### **Proposal**

Project: NRH20

### Change Order Request # 005 REV 1

120 SLIDE REPLACEM

MR-2

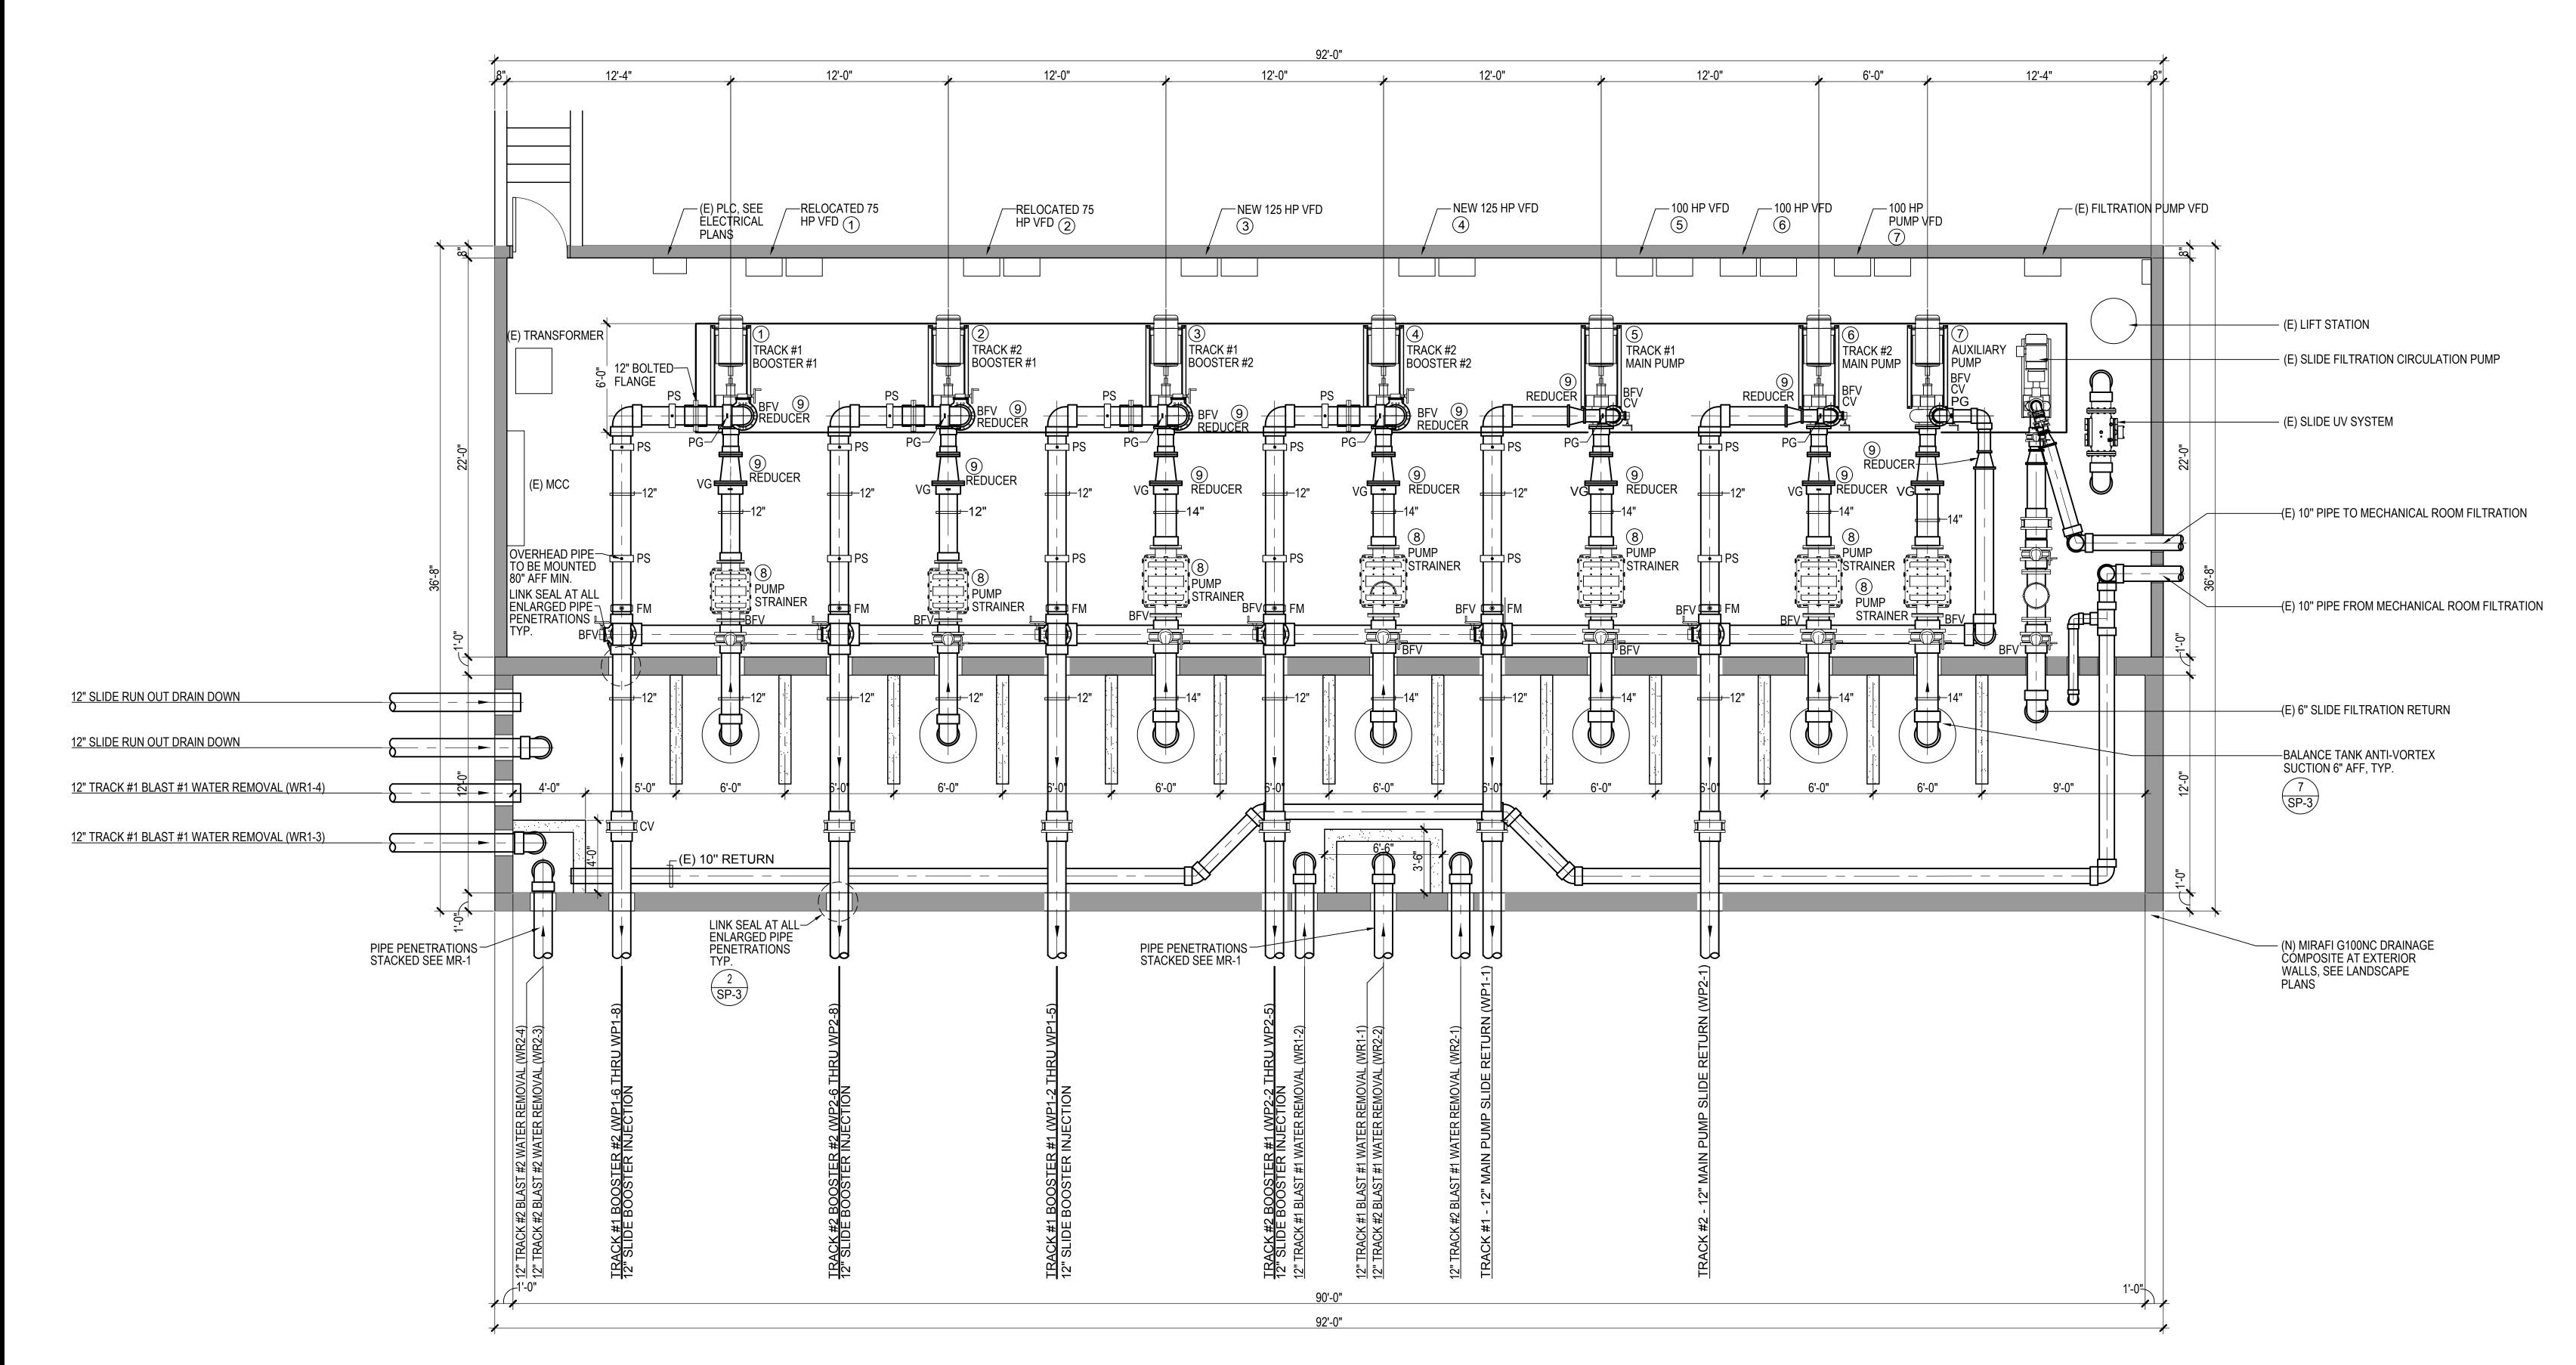
- Install plumbing per revised drawing MR-2 on 4 pumps
  - Relocate 75HP Pump to Track#1 Booster#2
  - Relocate 75HP Pump to Track#2 Booster#2
  - Furnish & Install(F&I) Grundfos 125HP Pump to Track#1 Booster#1

- o Furnish & Install Grundfos 125HP Pump to Track#2 Booster#1
  - Check valves should be installed in mechanical space as there is a drain line on the manifold to allow for winterization.
     Installing the check valves in the baffle tank area as indicated on the plan will require each check valve to be removed for winterization/drainage of the associated discharge line.

- o Titan CV90-DI with NSF rated coating Check valves included in lieu of Flomatic(not manufactured in 12")
- Rewire Switchgear and pumps as required per revised layout drawing MR-2

- F&I 2 EA 125 HP Variable Frequency Drive(VFD)
  - o Relocate 75HP VFDs as indicated on MR-2
  - F&I breakers for 2 EA 125HP Motors
  - F&I new conduit and wire from switchgear to 2 EA 125HP VFDs and 2 EA 75HP VFDs

- o F&I new conduit and wire from VFDs mentioned above to corresponding motors
  - o 1 day programming of VFDs to parameters provided on MR-2
- Remove (2) 30HP pumps from pump room (location designated by ownership).

· —
REVISIO	NS	
NO.	DATE	DESCRIPTION
Δ1	8-20-25	PUMP/PLUMBING MODIFICATIONS
